Bulletin Number: RV-001
Effective: October 1, 1990

NEW FOUR-BOLT FLOOR FLANGES

Affected Models: *All Traveler® toilets.*

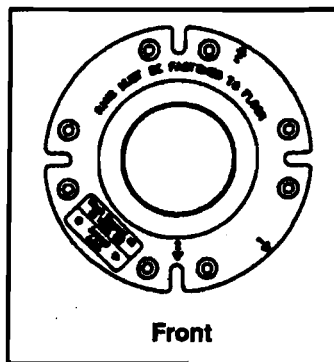
Position 1 is for use with SeaLand toilets.

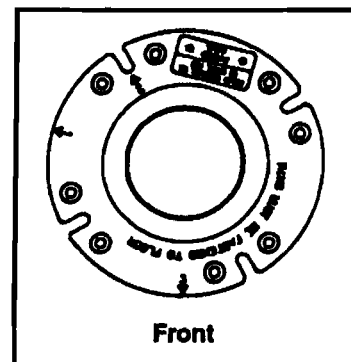
Position 2 is for two bolt toilets with a 3 o'clock & 9 o'clock alignment. Such as Thetford AquaMagic IV, Sanitation Equipment Perma Flush and Valterra LeToilete.
